UNITED STATES PATENT AND TRADEMARK OFFICE

APPLICATION NO.	FILING DATE	FIRST NAMED INVENTOR	ATTORNEY DOCKET NO.	CONFIRMATION NO.
10/721,808	11/25/2003	Antony J. Lozier	ZIM0143	6206
43963	7590 07/25/2006		EXAMINER	
ZIMMER TECHNOLOGY - BAKER & DANIELS			HOFFMAN, MARY C	
	11 EAST WAYNE STREET, SUITE 800 ORT WAYNE, IN 46802		ART UNIT	PAPER NUMBER
	•		3733	
			DATE MAILED: 07/25/2000	5

DETAILED ACTION

See Arrows

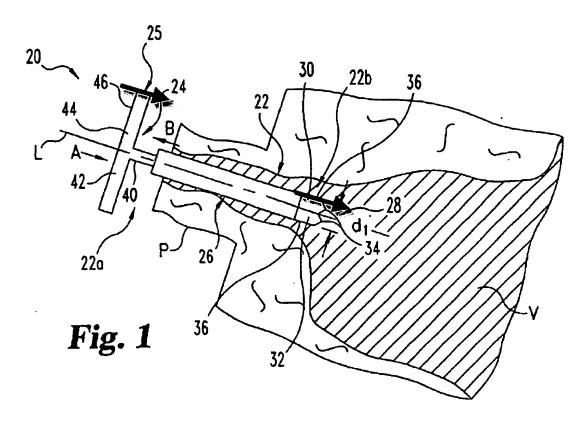
Chappuis et al. a reamer comprising a shank (ref. #26), a reamer body having a longitudinal axis, and a blade (ref. #30, 32 plus deformation means, i.e. "a spring or spring like device"- not shown, discussed in col. 6, lines 49-51) formed in the reamer body, the blade capable of being deformed between a contracted position and an expanded position. The shank has a radius measured from the longitudinal axis, the blade in the contracted position extending no further from the longitudinal axis than the radius of the shank. The shank has a radius measured from the longitudinal axis, the blade in the expanded position extending further from the longitudinal axis than the radius of the shank. The blade in the contracted position is substantially parallel to the longitudinal axis. The blade in the expanded position comprises a portion oriented radially outward from the longitudinal axis. The blade comprises at least one deformation point, meaning that the blade has a point at which the blade is capable of

being deformed. The reamer further comprises an actuating means (ref. #24, col. 5, lines 49-50) for moving the blade between the contracted position and the expanded position. The shank (ref. #26) is cannulated and the actuating means comprises an elongate member connected to the blade, proximate translation of the elongate member moving the blade from the contracted position to the expanded position, and distal translation of the elongate member moving the blade from the expanded position to the contracted position. The blade is biased to the expanded position and is collapsible to the contracted position upon application of a radially inward force upon the blade, and that the biasing force urging the two blades outwards is due to "a spring or spring like device". (col. 6, lines 46-51). The reamer body comprises a shaft having a polygonal cross-section, an edge of the blade being coincident with an apex formed by two adjacent sides of the polygonal reamer body (FIG.1 marked-up copy).

The deformation means for deforming the blade between a contracted position and an expanded position is the relative movement of ref. #24 and ref. #26.

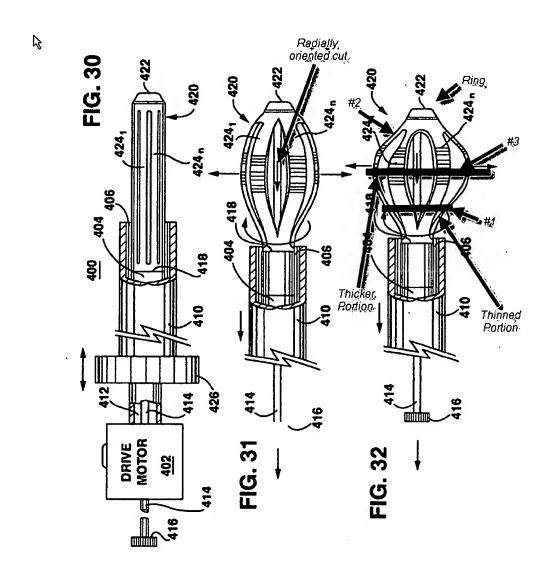
Claims 1-11, 13-14, 16-21, 23-24 and 26 are rejected under 35 U.S.C. 102(e) as being anticipated by Cragg et al. (WO 01/60262), cited by applicant.

Cragg et al. disclose reamer comprising a shank (ref. #406), a reamer body (ref. #420) having a longitudinal axis, and a blade (ref. #424) formed in the reamer body, the blade deformable between a contracted position and an expanded position. The shank has a radius measured from the longitudinal axis, the blade in the contracted position extending no further from the longitudinal axis than the radius of the shank. The shank

has a radius measured from the longitudinal axis, the blade in the expanded position extending further from the longitudinal axis than the radius of the shank. The blade in the contracted position is substantially parallel to the longitudinal axis. The blade in the expanded position comprises a portion oriented radially outward from the longitudinal axis. The blade comprises at least one deformation point (see middle portion of ref. #424). The at least one deformation point comprises an exterior circumferential relief (see #1 in marked-up copy below). The exterior circumferential relief is formed in a proximate end of the blade, the reamer further comprises a ring (ref. #422) coupled to a distal end of the blade, and the at least one deformation point further comprises an exterior circumferential relief formed in the distal end of the blade (see #2 in marked-up copy below). The at least one deformation point comprises at least one interior circumferential relief formed in the blade between the proximate end and the distal end (see #3 in marked-up copy below). The deformation point of the reamer can also be considered as the slits between ref. #'s 424, i.e. the at least one deformation point comprises a radially oriented cut in the blade. The at least one deformation point comprises a thinned region (see the diameter of #1 and #2 in the marked-up copy below relative to the thicker portion denoted by #3). Moreover, on page 26 of the specification, lines 11-12, the reference discloses that the blades can be made in any shape. Therefore, this would include the basic hourglass shape, and a blade of this shape would meet the limitations as currently set forth in the claims. The reamer of further comprises an actuating means (ref. #404) for moving the blade between the contracted position and the expanded position. The shank is cannulated and the actuating means

comprises an elongate member connected to the blade, proximate translation of the elongate member moving the blade from the contracted position to the expanded position, and distal translation of the elongate member moving the blade from the expanded position to the contracted position. The blade is biased to the expanded position and is collapsible to the contracted position upon application of a radially inward force upon the blade. The deformation means for deforming the blade between a contracted position is by the relative movement of the components.
